**SHINE MEDICAL TECHNOLOGIES, LLC**

**SHINE MEDICAL TECHNOLOGIES, LLC OPERATING LICENSE APPLICATION  
RESPONSE TO REQUEST FOR ADDITIONAL INFORMATION**

##### RAI 1-1

**Figure 1.3-1 – Main Production Facility Building General Arrangement**

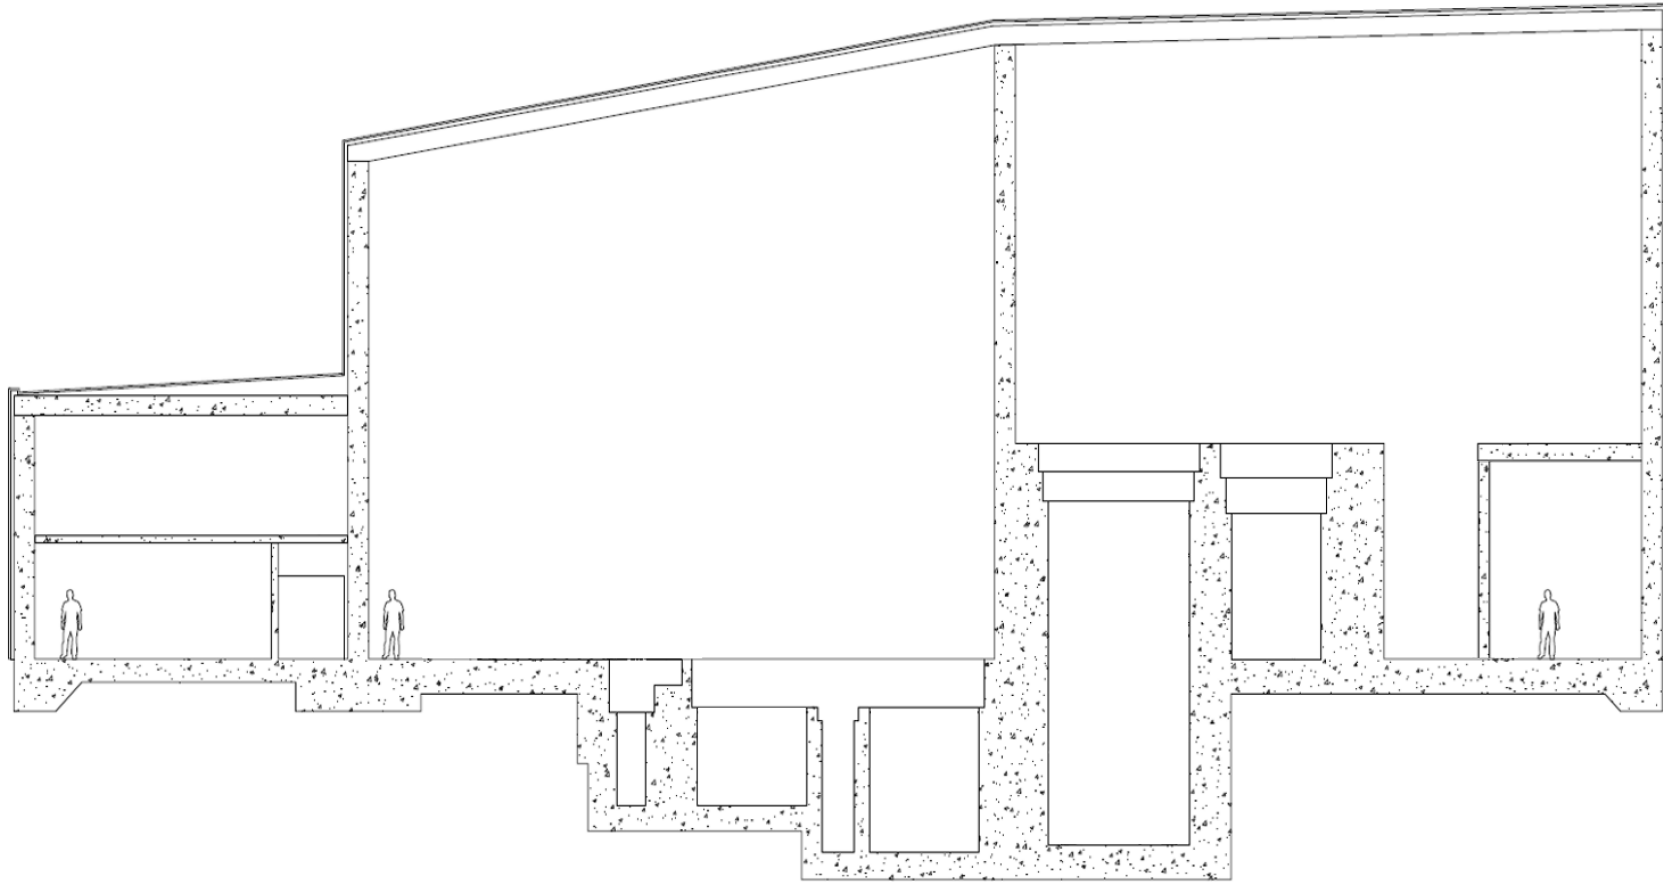
Provide clear definitions of all terms used to refer to the SHINE Medical Isotope Production Facility, the irradiation facility, and radioisotope production facility, updating the FSAR as necessary.

- The term "main production facility" specifically describes the SHINE building which contains both the "irradiation facility" and the "radioisotope production facility." Figure 1.3-1 of the FSAR provides a plan view of the "main production facility."

SHINE has revised the FSAR to ensure consistent use of these defined terms, to remove use of the term "SHINE production facility," and to correct the name of the material staging building. A mark-up of the FSAR incorporating these changes is provided as Attachment 1.
